**NOTICE OF MEETING**  
**Murray City Center District Review Committee Meeting**  
**4646 South 500 West**  
**MURRAY, UT 84123**

## AGENDA ITEM # 2 - Murray Theater

<b>ITEM TYPE:</b>			
<b>ADDRESS:</b>	4959 – 4963 South State Street	<b>MEETING DATE:</b>	July 28, 2022
<b>APPLICANT:</b>	Murray City Parks & Recreation	<b>STAFF:</b>	Jared Hall, CED Director
<b>PARCEL ID:</b>	22-07-157-011	<b>PROJECT NUMBER:</b>	22-061
<b>ZONE:</b>	MCCD, Murray City Center District		
<b>SIZE:</b>	.21 acre		
<b>REQUEST:</b>	Murray City is requesting design review approval for the planned renovation of the Murray Theater.

Figure 1 - Zoning and surrounding uses

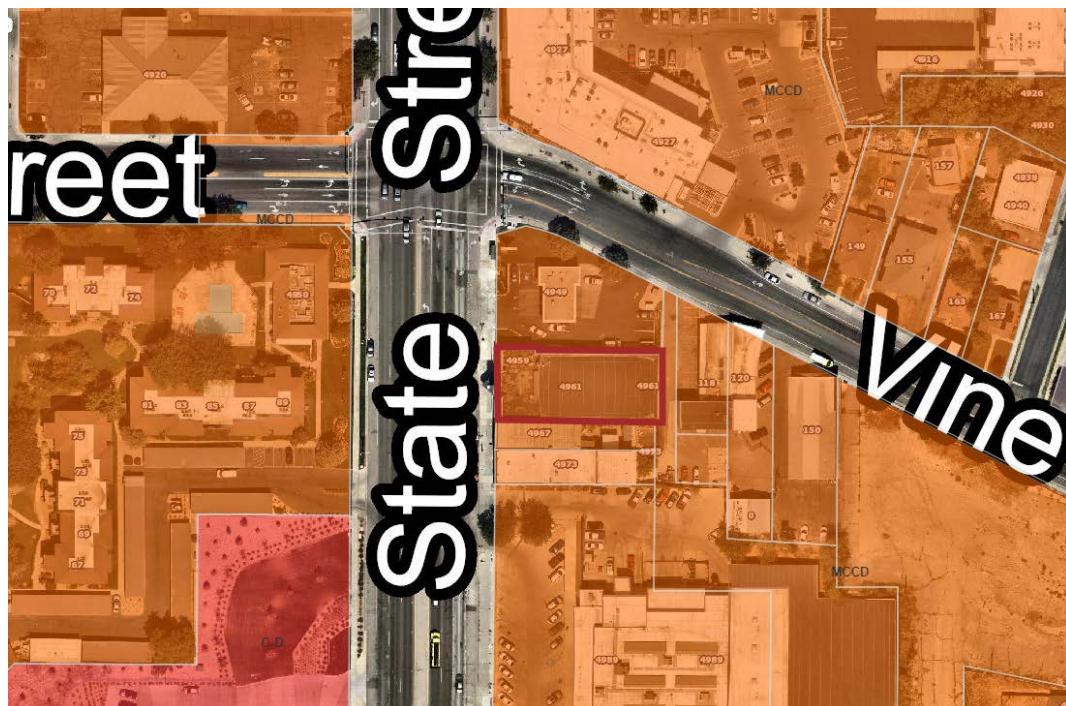
The subject property is located on the east side of State Street, just south of Vine Street. Murray City plans to renovate the historic building for use as a theater again.
